**HITCH RACK RANCH QUARRY**

**M-2017-049**

## **RESPONSE TO THIRD ADEQUACY REVIEW**

#### **Hitch Rack Ranch Pit Wall Geotechnical Assessment:**

Figure 1: Hitch Rack Ranch Pit Wall – Plan View with Cross-section Location

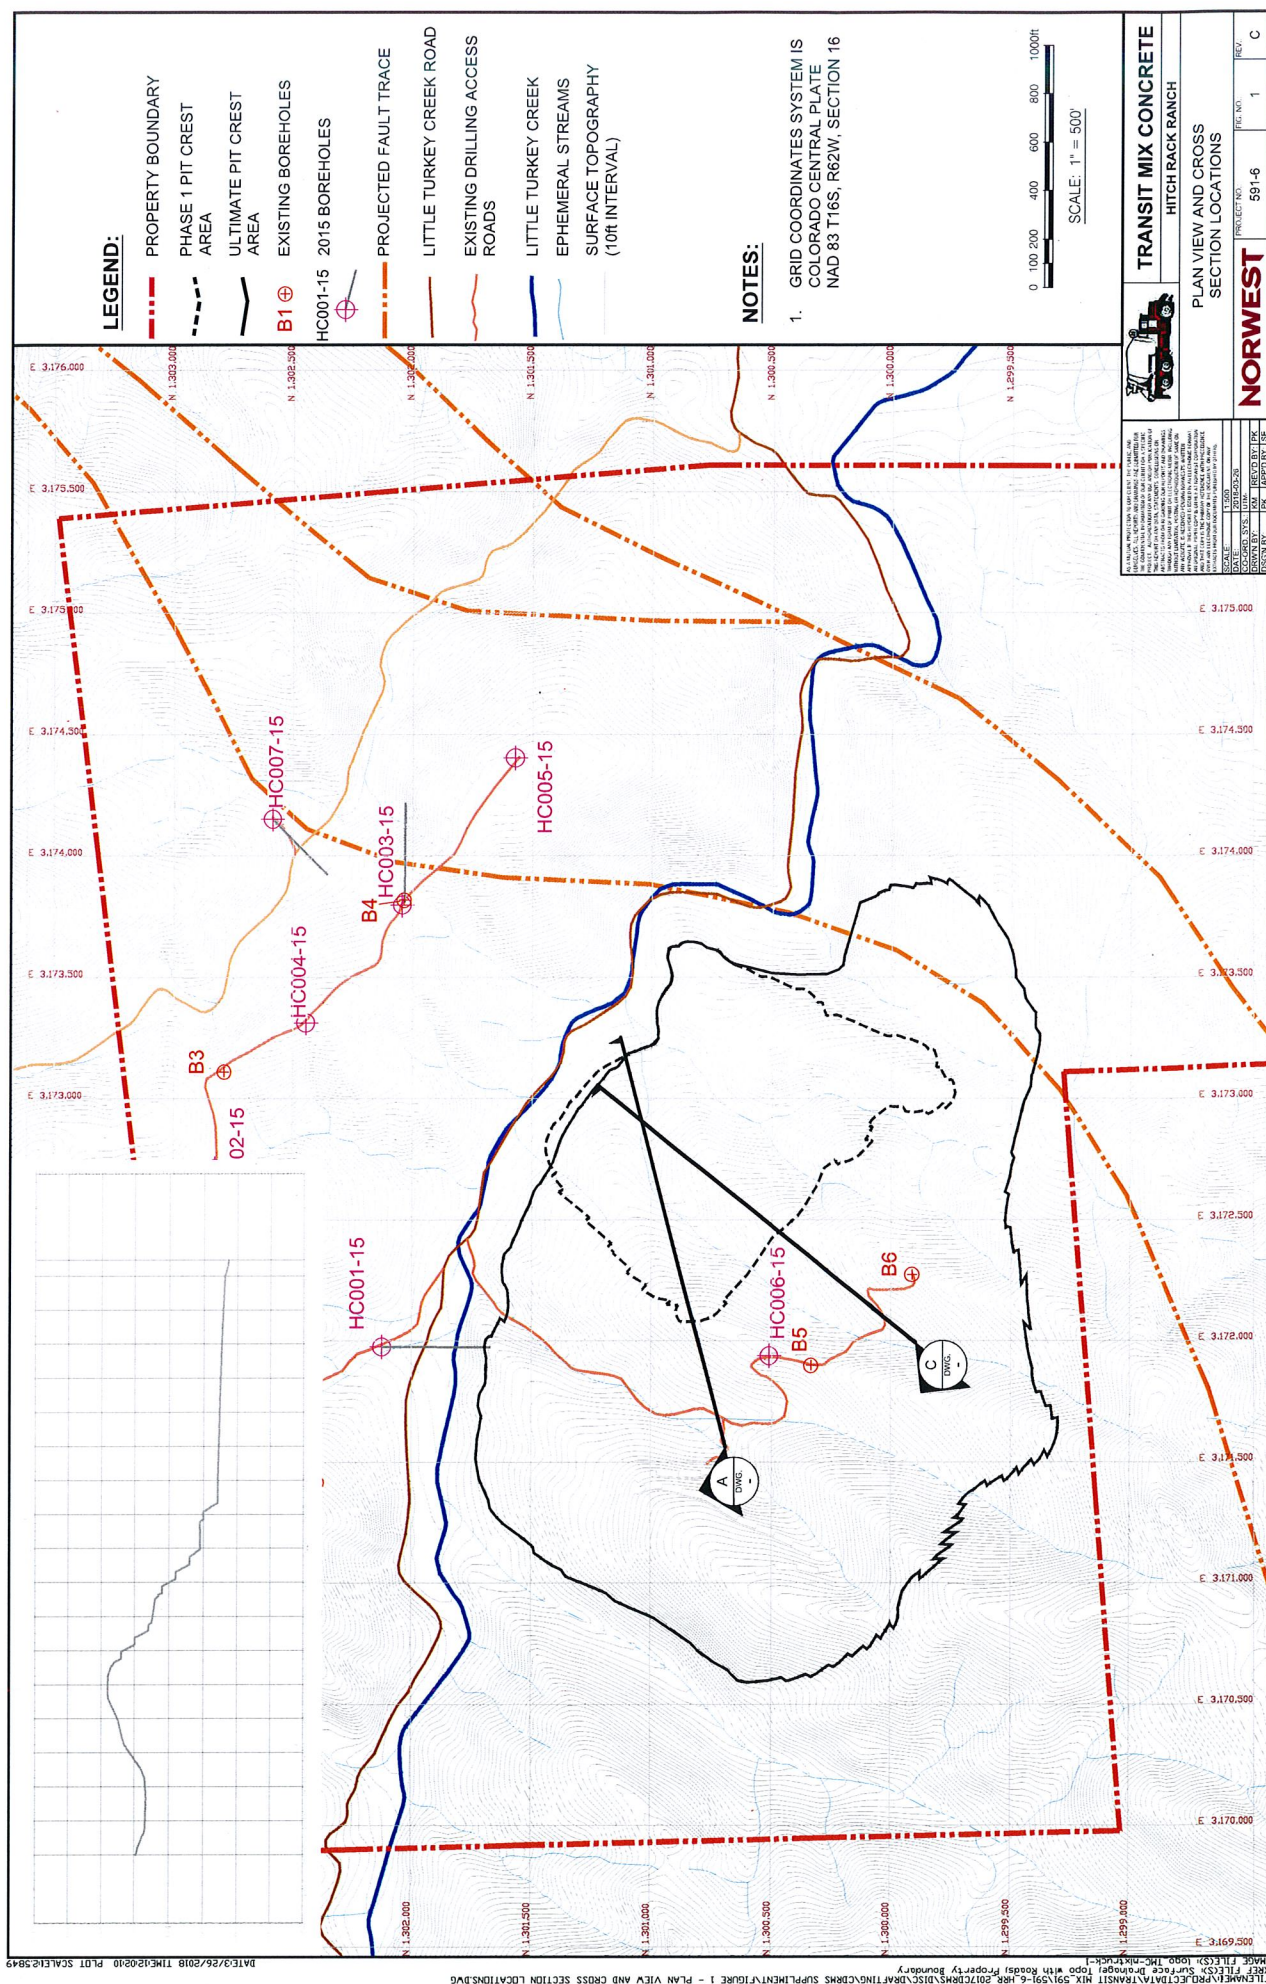
1. In response to Item #31 of the Adequacy Review of Exhibit 6.5 – Geotechnical Stability Memorandum dated December 28, 2017, the Applicant states a map showing the L-E section lines has been included as an attachment to the geotechnical analysis and report. The Division did not receive the L-E section lines map with the Applicant's adequacy response. Please provide a map indicating the cross-section profile locations for the Geotechnical Model Analysis for the Slope L-E models.

**Response:** Transit Mix has included with this response a memorandum from Norwest Corporation to supplement the Pit Wall Geotechnical Assessment. This memorandum provides a map showing the L-E section lines and provides the Slope/W model reports and a summary of the analysis and results.
